FAILURE MODE, EFFECTS, AND CRITICALITY ANALYSIS (FMECA)  
OF THE WEST VALLEY NUCLEAR SERVICES  
SUPERNATANT TREATMENT SYSTEM AND  
THE CEMENT SOLIDIFICATION SYSTEM

DECEMBER 1987

FIGURE 4  
 SUPERNATANT TREATMENT SYSTEM  
 FILTRATION AND COOLING SECTION  
 FLOW DIAGRAM

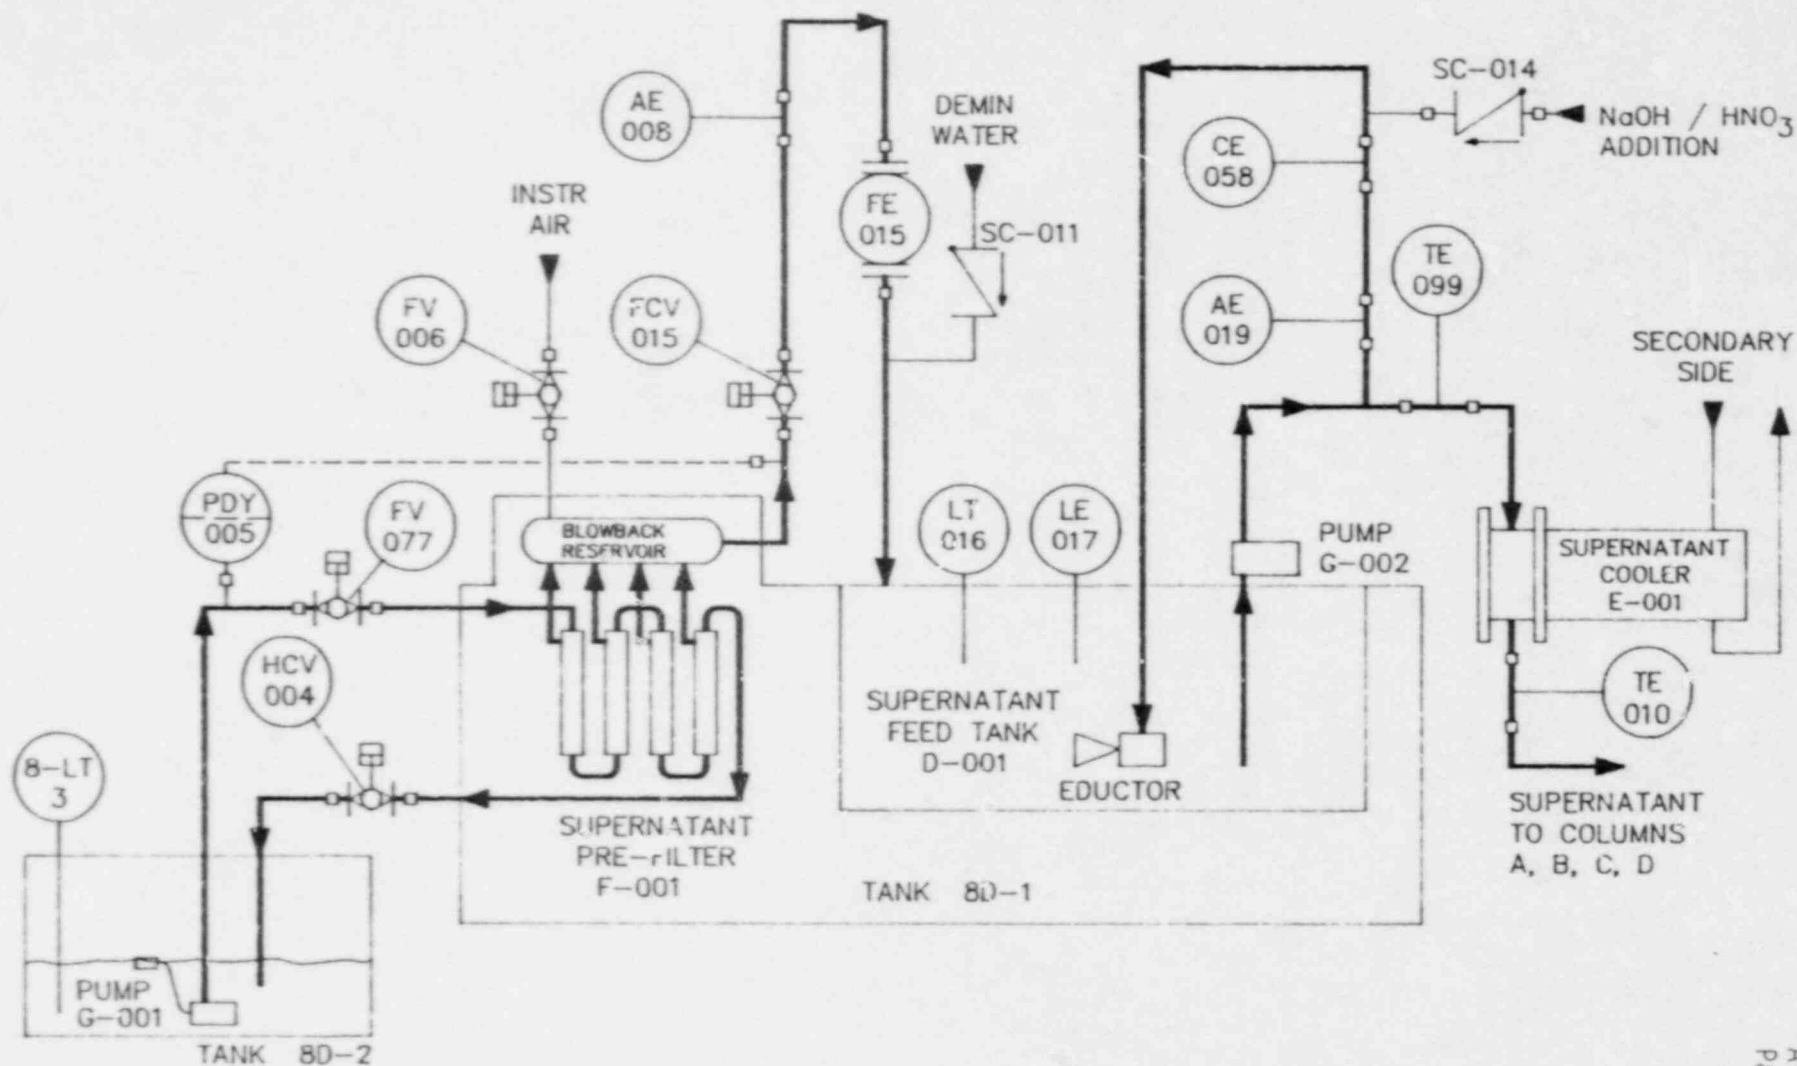
The 1 micron sintered metal filter medium is highly susceptible to plugging. In addition, successful blowback sequence completion requires careful operator attention and interpretation of system conditions and the collective reliability of numerous components. The blowback and system stabilization cycle duration takes approximately 15 minutes to complete. Additional blowback cycles must be operator initiated if flow/pressure parameters are not within operating limits. These conditions add to the difficulty of maintaining the filters in an acceptable "unplugged" condition.

Recommendation: Test actual supernatant containing sediments in a small scale test model. Evaluate the use of larger media orifice size if possible. Consider purchase of spare filter elements and provide a verified replacement procedure prior to hot startup.

FIGURE 8

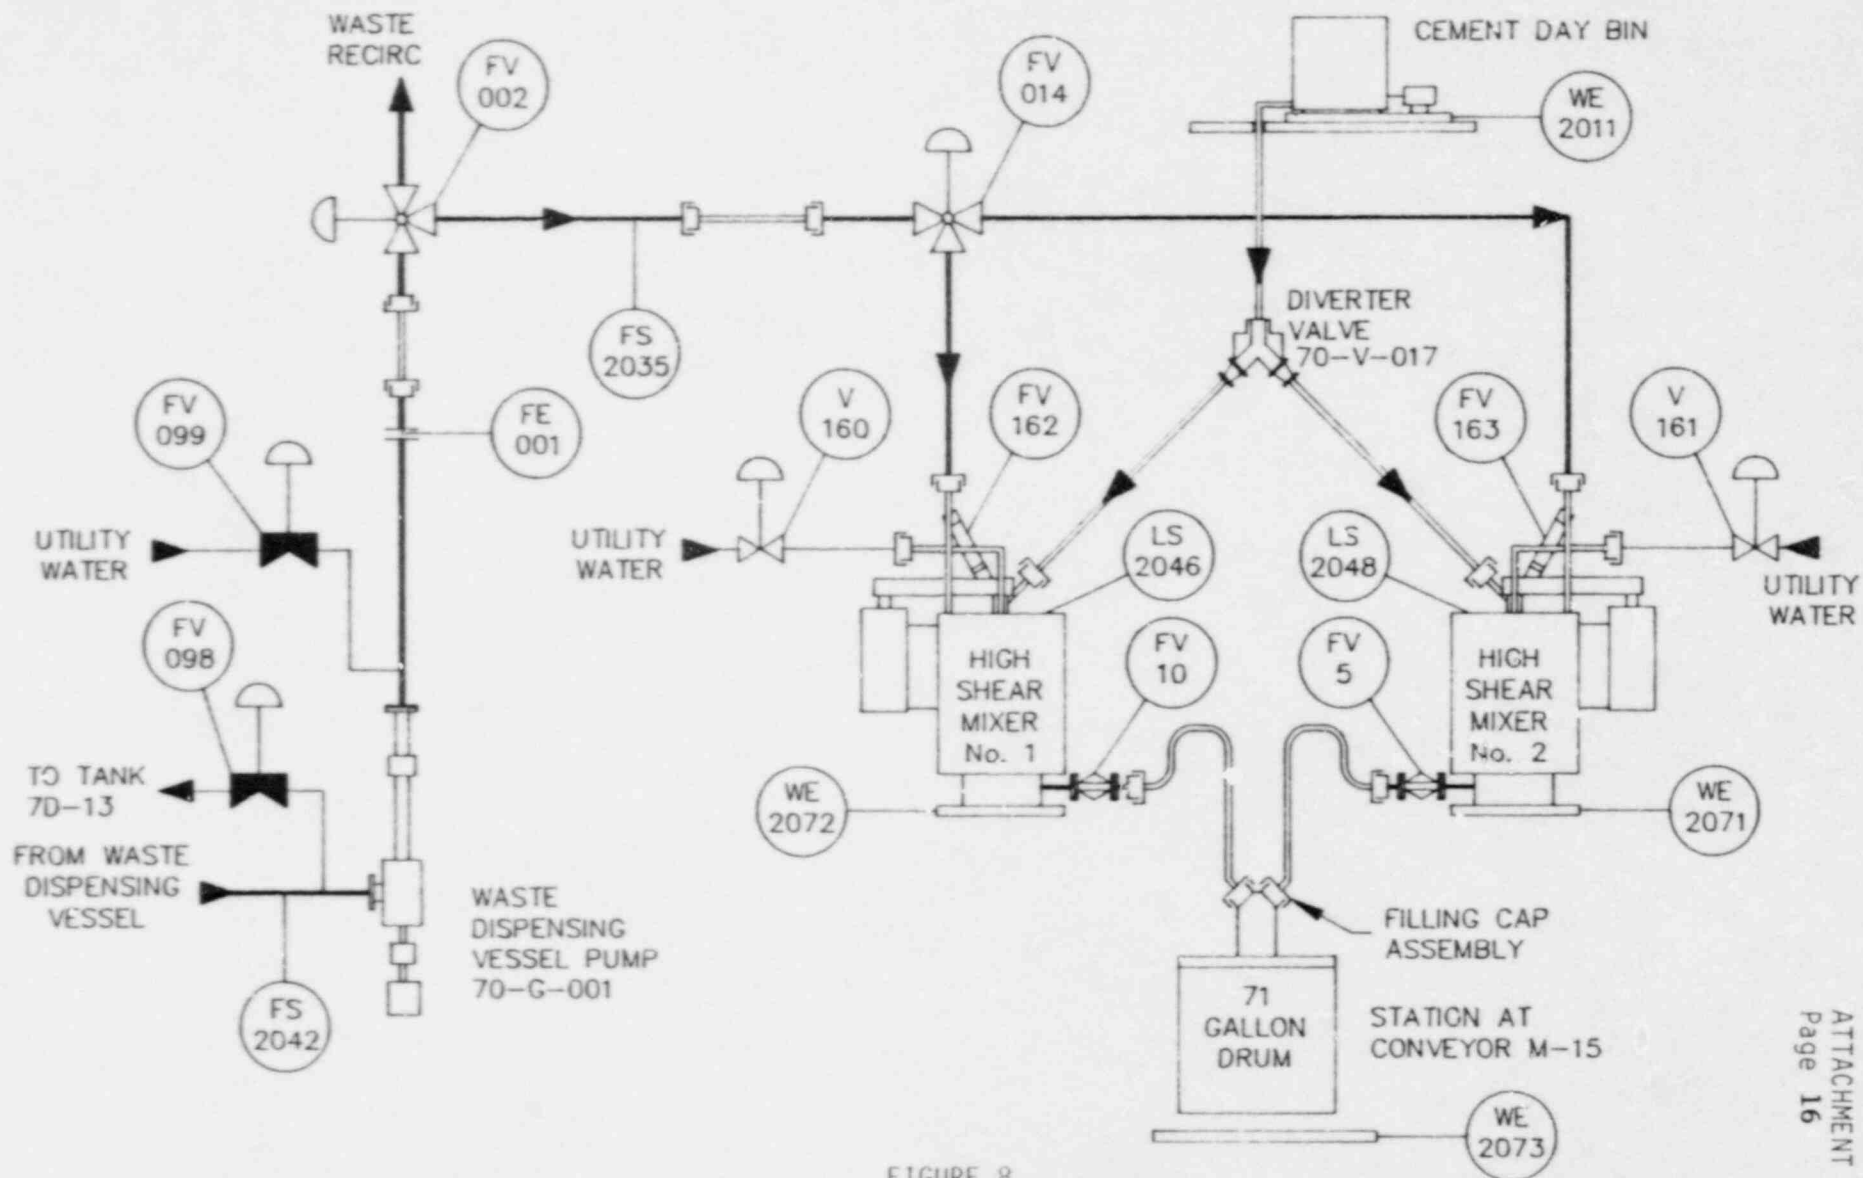
If too much cement is added, potential exists that a low water/cement ratio could cause cement setup in mixer.

The open or partially open failure of the FV-5 and FV-10 pinch valves causes the CSS process to be unable to continue. The likelihood of a pinch valve failing due to clogging appears to have a high probability in the projected two-year operation of the CSS. The valves being located horizontally have the potential to allow cement to remain in the valves. The downtime to fix, flush, or replace the valve should not be extensive if the parts are readily available. However, if the failure occurs during a batch cycle, the waste may empty to the drum before the addition of cement. If the valve failed during mixing, this would result in a premature mixture dump of cement into the drum.

If the cement diverter valve is stuck partially open to one mixer or closed to both mixers, the program cannot continue. If waste/cement is in one mixer, then that mix cycle can be finished, but significant downtime may occur to fix or replace the cement diverter valve before the entire process can continue. This valve was projected to have a high failure probability because it has two cylinders, four limit switches, and interconnecting linkages associated with its operation.

Recommendation: Modify the HSCSS/DAS to limit the amount of time that the cement feeder may operate to ensure that excessive amounts of cement cannot be added.
